PLANNING REPORT

Block J Ellis Parking Garage 25-087AD

Review and approval of an Administrative Departure to allow a minor deviation to the drive aisle width of an approved parking garage.

Floor Plan

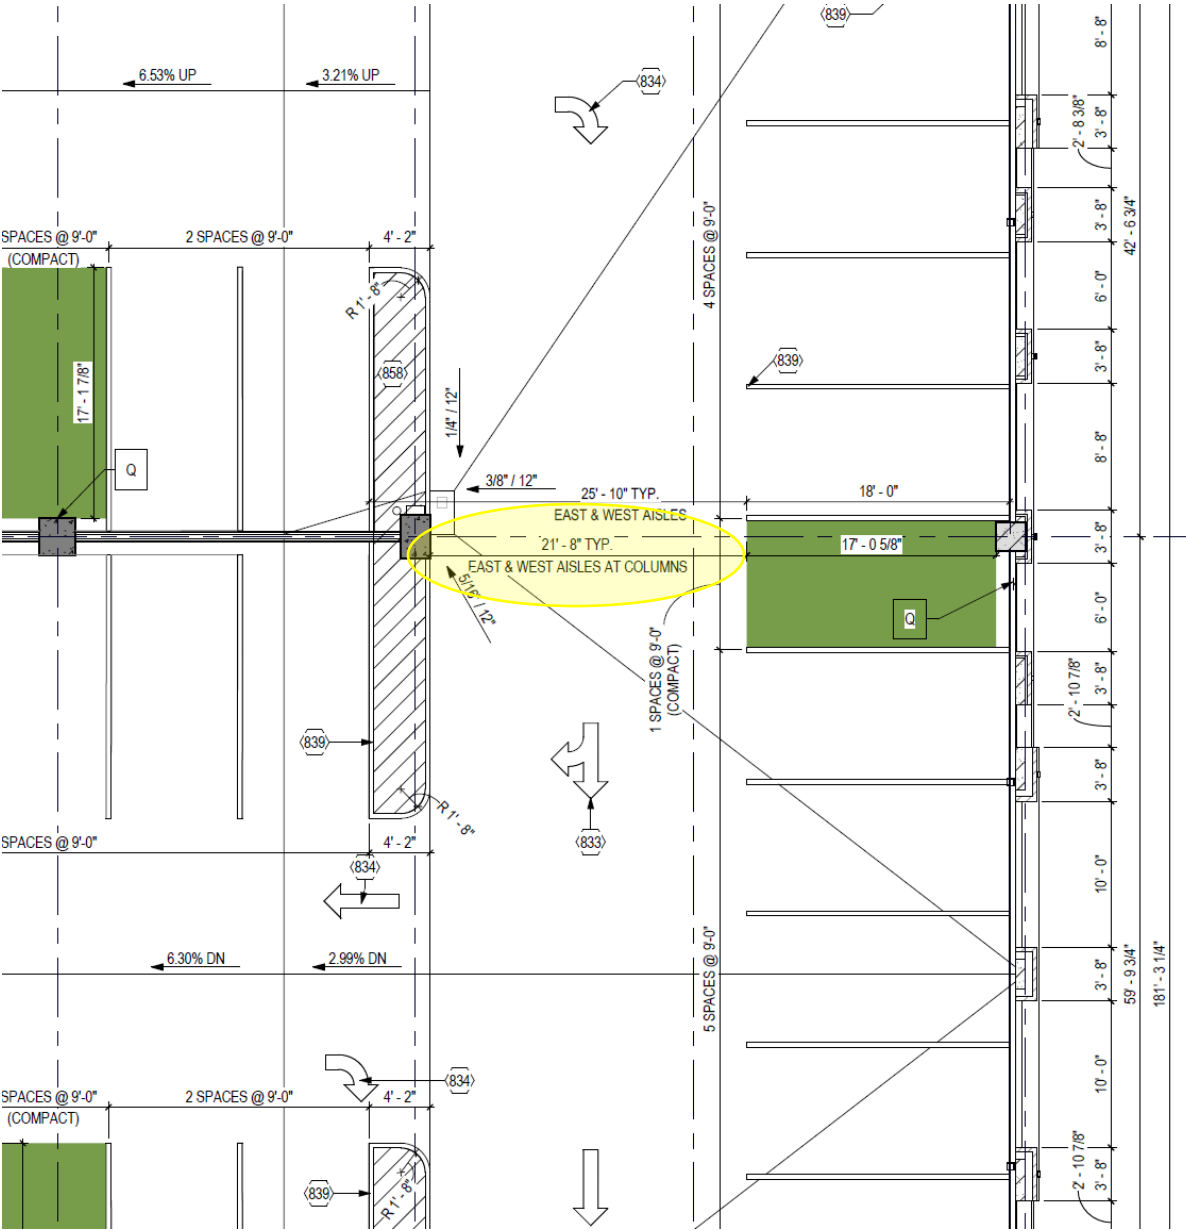
The applicant is requesting a deviation from Zoning Code Section 153.065(B)(4) to allow a drive aisle width of 21 feet – 8 inches on the east and west drive aisles in the upper stories of the garage. Drive aisle widths for 90-degree parking is required to be 22 feet. The deviation is requested due to the location of columns adjacent to the east and west drive aisles that reduce the width of the lanes by 4 inches. This condition is only applicable adjacent to the columns, as the remainder of the aisles within the structure meet the 22-foot requirement. To address concerns of the narrower drive aisles, the applicant will implement one-way circulation

throughout the garage. This is consistent with several other garages in the Bridge Park development.

Planning Recommendation: Approval of the Administrative Departure to Zoning Code Section 153.065(B)(4) to allow a drive aisle width of 21 feet and 8 inches.
